### NCC 2019 Section J Part J1 Statement of Compliance

**SUBJECT PREMISE: Opal RACF, St Clair | 94-100 Explorers Way, St Clair NSW 2759**

## Attachment A – JV3 Modelling Results:

## Attachment C – Building Fabric Requirement Markups

Sheet Title  
**GENERAL ARRANGEMENT PLAN -  
LEVEL 1**

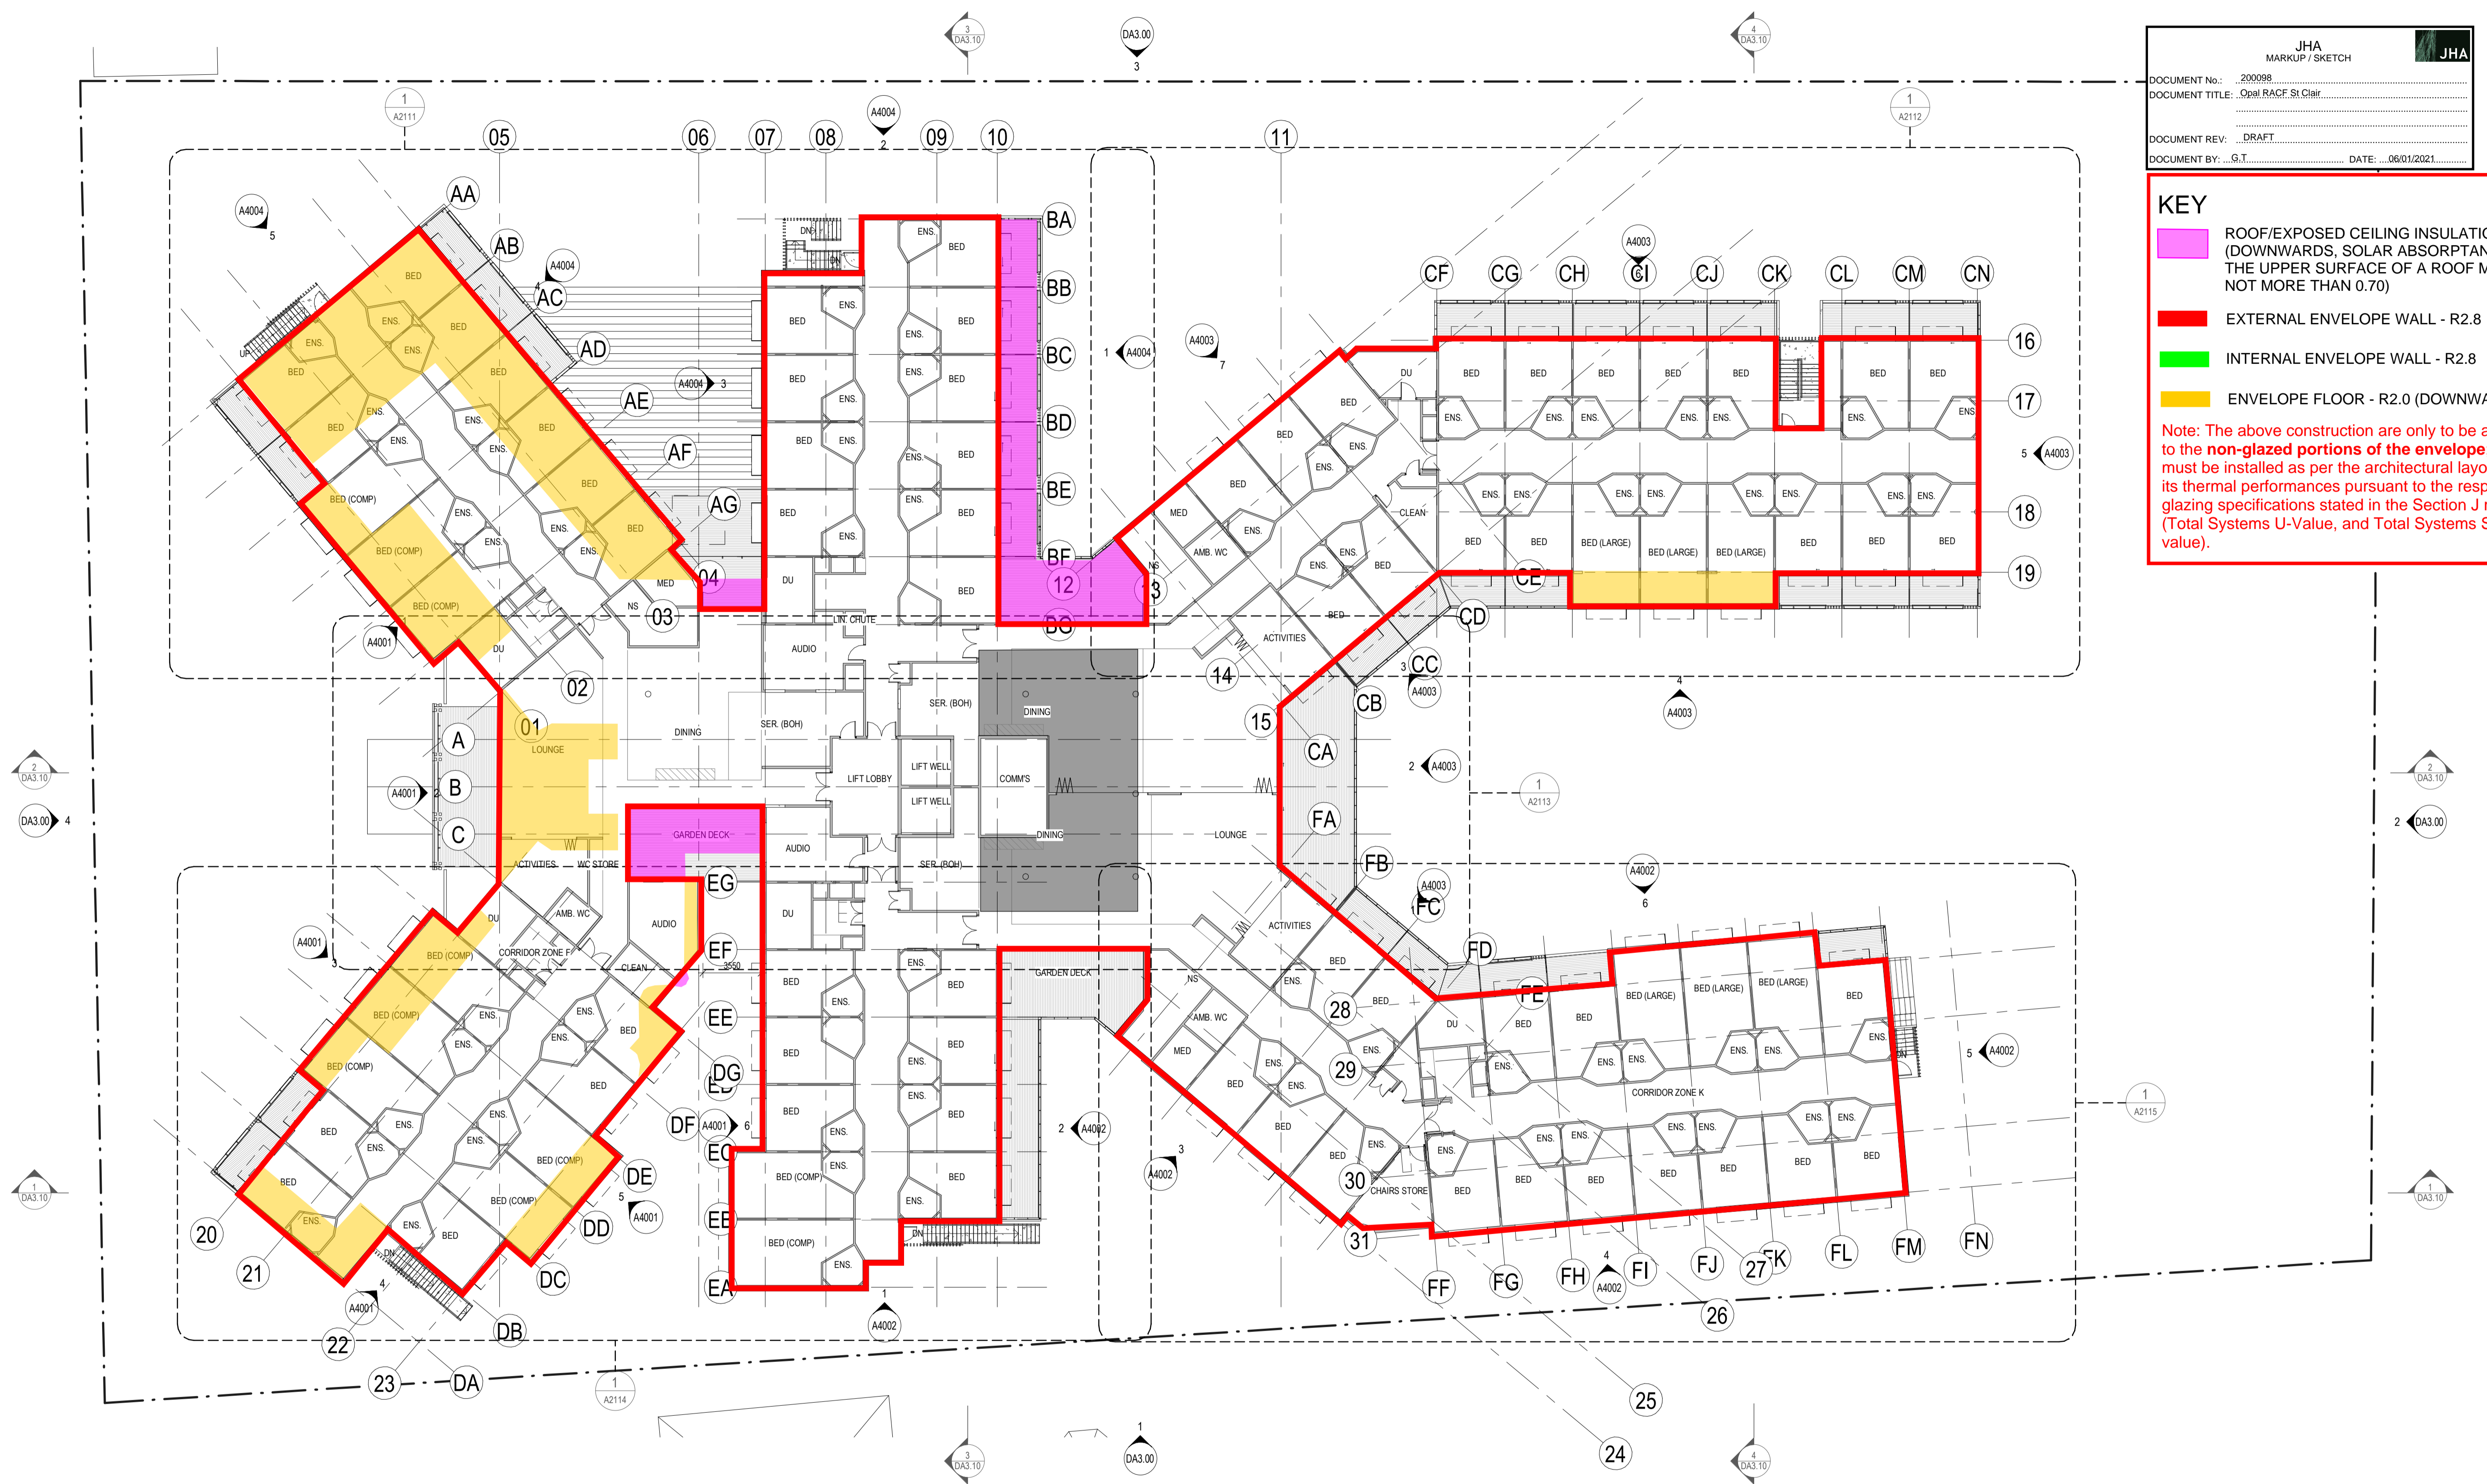
- ROOF/EXPOSED CEILING INSULATION - R3.2 (DOWNWARDS, SOLAR ABSORPTANCE OF THE UPPER SURFACE OF A ROOF MUST BE NOT MORE THAN 0.70)
- EXTERNAL ENVELOPE WALL - R2.8
- INTERNAL ENVELOPE WALL - R2.8
- ENVELOPE FLOOR - R2.0 (DOWNWARDS)

Note: The above construction are only to be applied to the non-glazed portions of the envelope; glazing must be installed as per the architectural layouts with its thermal performances pursuant to the respective glazing specifications stated in the Section J report (Total Systems U-Value, and Total Systems SHGC value).

Sheet Title  
**GENERAL ARRANGEMENT PLAN - ROOF PLAN**

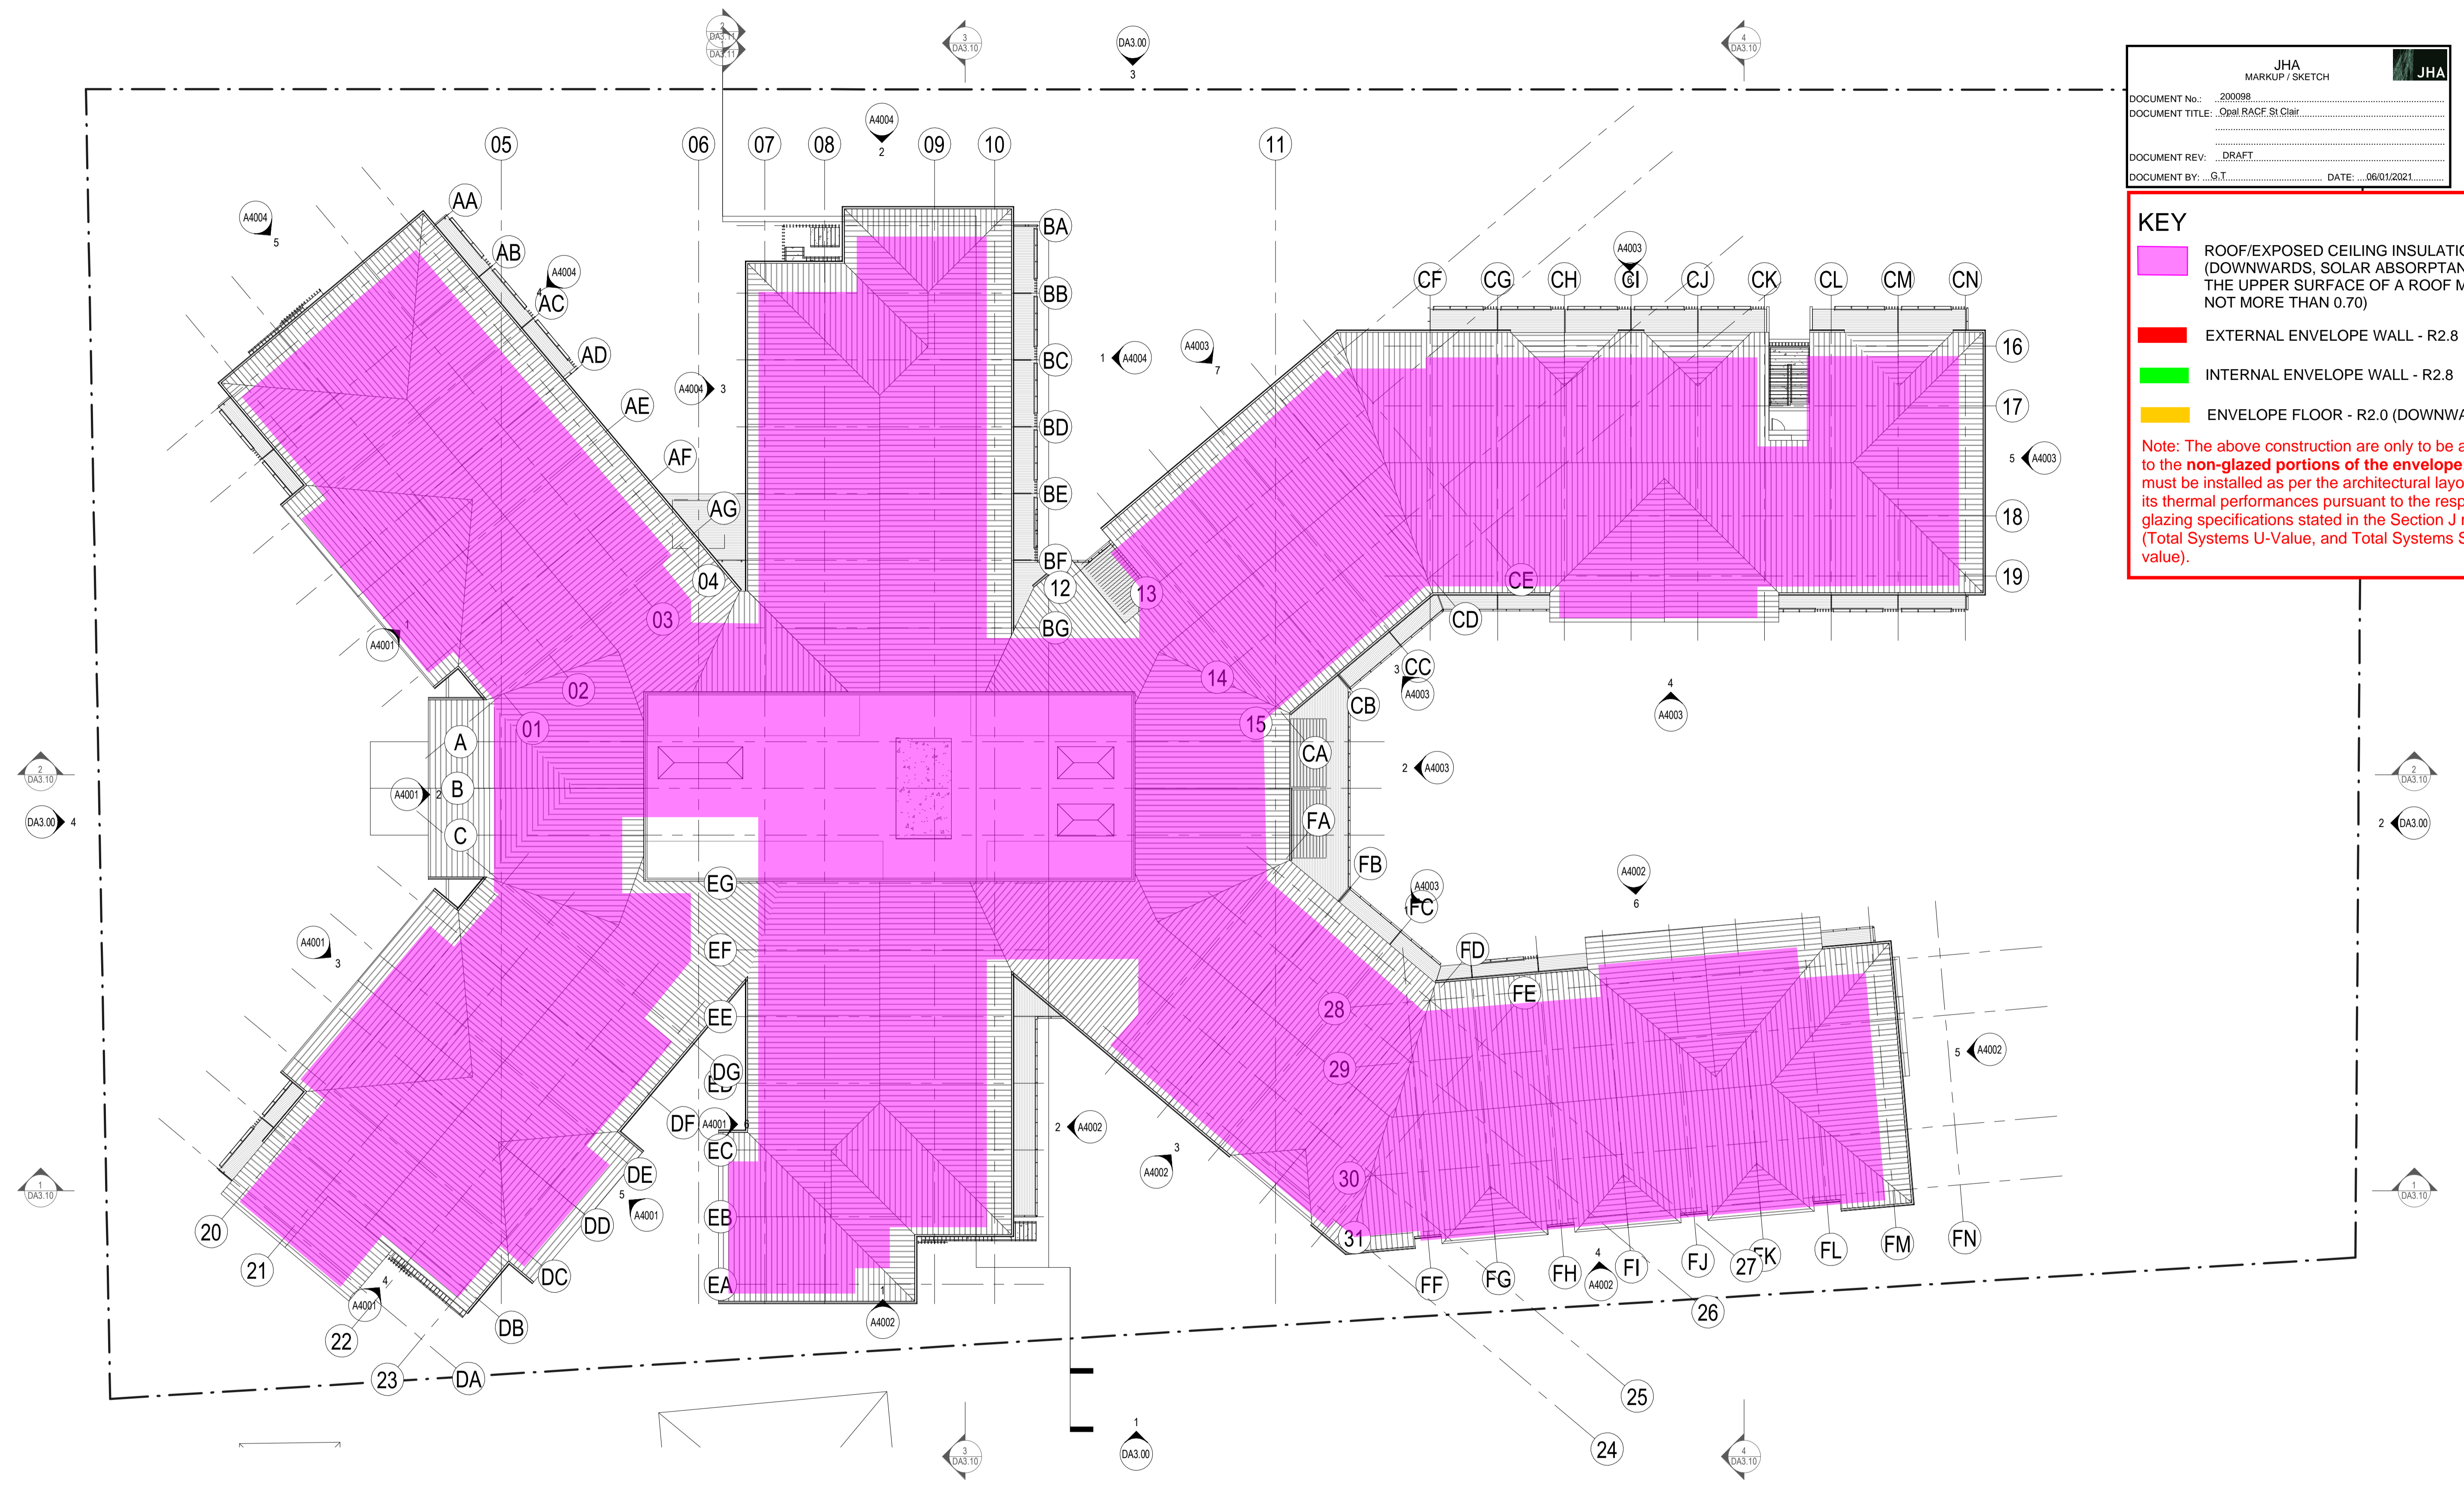
- ROOF/EXPOSED CEILING INSULATION - R3.2 (DOWNWARDS, SOLAR ABSORPTANCE OF THE UPPER SURFACE OF A ROOF MUST BE NOT MORE THAN 0.70)
- EXTERNAL ENVELOPE WALL - R2.8
- INTERNAL ENVELOPE WALL - R2.8
- ENVELOPE FLOOR - R2.0 (DOWNWARDS)

**Note:** The above construction are only to be applied to the **non-glazed portions of the envelope**; glazing must be installed as per the architectural layouts with its thermal performances pursuant to the respective glazing specifications stated in the Section J report (Total Systems U-Value, and Total Systems SHGC value).
